CODAN

Design fault in the DSP Modem PCB in the 9001 Fax & Data Interface

Figure 1: Position of the DSP Modem PCB in the 9001

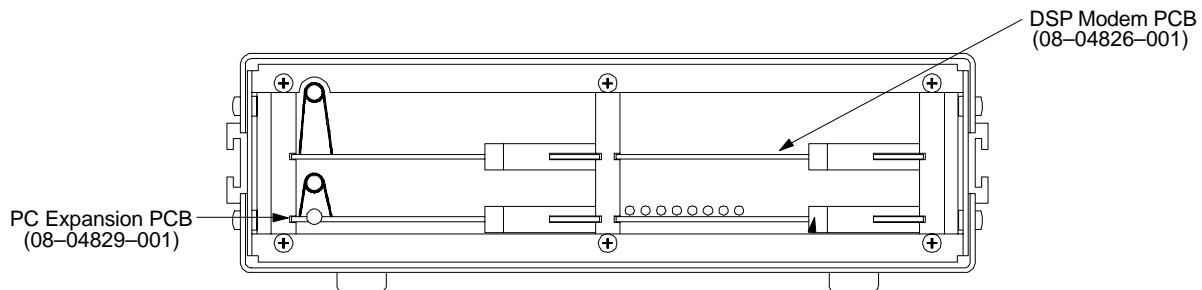
- Switch the power off to the 9001.
- Remove the front panel of the 9001 by removing the four securing screws.
- Locate the slot containing the DSP Modem PCB at the top right-hand corner of the interface (see Figure 1).
- Pull the lever forward and remove the DSP Modem PCB (part number 08-04826-001).

- Replace the DSP Modem PCB in the slot at the top right-hand corner of the 9001 (see Figure 1).
- Replace the front panel of the 9001 and secure it into position with the four securing screws.
- Switch on the 9001 and try sending a text or binary file using 9102 Fax & Data Controller software.
 - ↪ If the 9001 begins sending the text or binary file, the problem has been rectified.

Figure 2: DSP Modem PCB

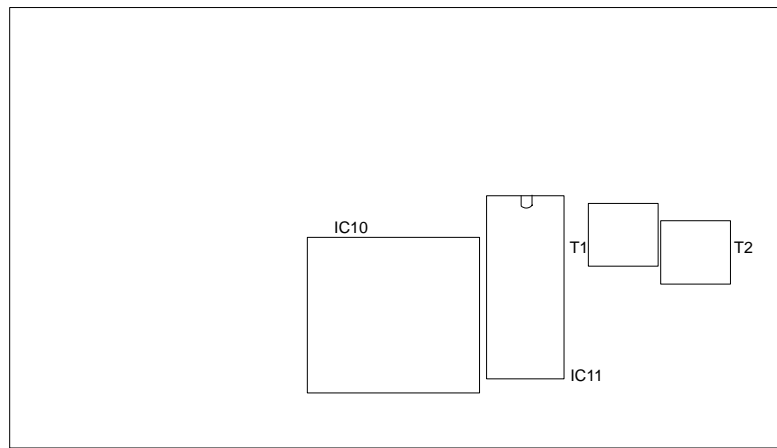
The “-ACK line” of the 9001 Fax & Data Interface is being held low as it passes through a via (a through-hole connection between the tracks on either side of the PCB). The via is shorting to the ferrite of T1.

The ferrite creates a 1 kΩ resistance to ground through the clip holding the two ferrites together. This creates a parallel port interrupt on the PC Expansion PCB (see Figure 1). This activity on the PC Expansion PCB initiates a “BUSY” response in the 9001, which responds as if it is printing. The most common cause of this problem is solder in the via running underneath T1.

- Locate the via, which runs directly underneath T1 (see Figure 2).

The via has a track between pins 27 and 26 of IC11.

To correct the problem, the solder in the via running underneath T1 on the DSP Modem PCB must be removed. To access the via, T1 must be removed.

- Desolder T1 from the DSP Modem PCB (see Figure 2).

Do not damage any of the pads on the PCB.

- Remove the solder with a solder wick.
 - ↪ Check that there are no sharp pieces of solder protruding from the via.
- Place a piece of insulating tape over the via.
 - ↪ Ensure that the via is completely covered by the tape.
- Resolder T1 to the DSP Modem PCB.

- Connect a multimeter (that reads ohms) to the via from underneath the PCB, and to the largest pad next to it, or a ground pin of an IC, e.g. pin 16 of any EPROM.

The multimeter should show a reading of approximately 3.5 M Ω .
- While the multimeter is still connected, push down lightly on T1.
